## **MVP Southgate Project**

Docket No. CP19-14-000

## **May 2019 Supplemental Filing Attachments**

## **Changes to the MVP Southgate Project Workspaces and the Pipeline Route Table and Figures**

**Figure 3**  
Sheet 1 of 1

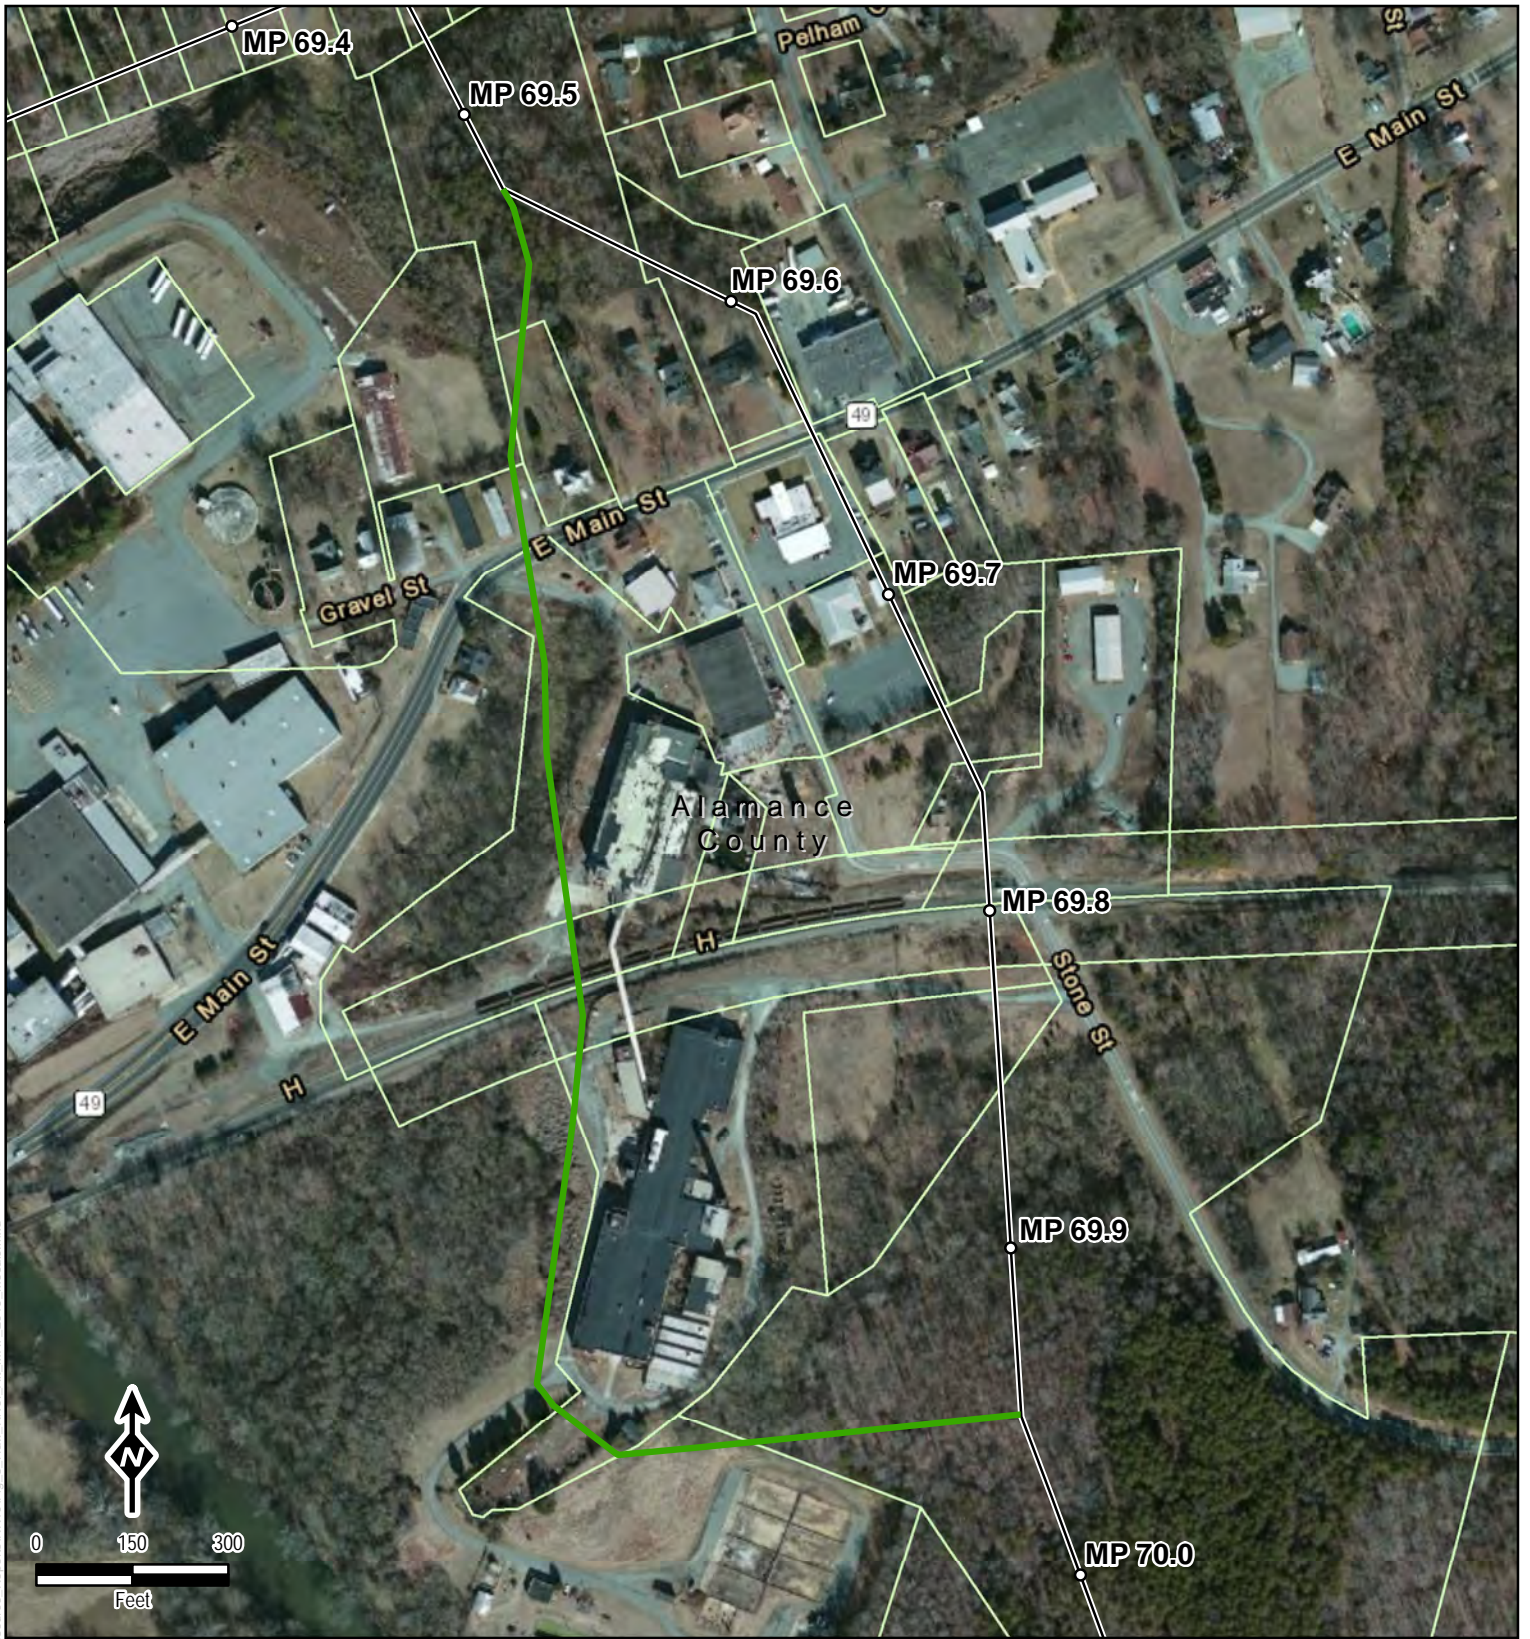
The Project evaluated a route variation that would relocate the current pipeline route to the west, further from the Town of Haw River. The Project evaluated the Town of Haw River Variation between approximate MP 69.52 and MP 69.95 (see Figure 3). At MP 69.52, this variation extends south for approximately 0.35 mile and crosses mixed forested and commercial/industrial land and E. Main Street and railroad tracks. The route then turns southeast and east for approximately 0.15 mile and crosses a combination of open and forest land before it rejoins the current pipeline route at MP 69.95.

- affects one fewer resident within 25 feet of the edge of the construction right-of-way;
- affect less forest land;
- eliminate impacts and inconveniences to the Town of Haw municipal building;
- eliminate impacts and inconveniences to the Town of Haw Fire Station;
- eliminate impacts to the Town of Haw River recreation center
- eliminate the need to remove or relocate outdoor pavilion;
- expedite general construction activities in the area due to the ability to mainline construct rather than stove pipe construct for the current route;
- reduce general inconveniences to residents of the Town of Haw River by moving construction activities to a less populated and less frequented part of the town; and
- reduce the number of foreign utility line crossings.

- greater length and associated land disturbance;
- repaving and resurfacing of Town of Haw River building parking lot;
- confined work areas;
- increased trench protection for public safety;
- increased occurrences of foreign utility lines that serve landowners; and
- increased traffic management and traffic inconveniences to residents.

Potential constructability concerns of the Town of Haw River Variation are:

- colocation with existing sewer and water line
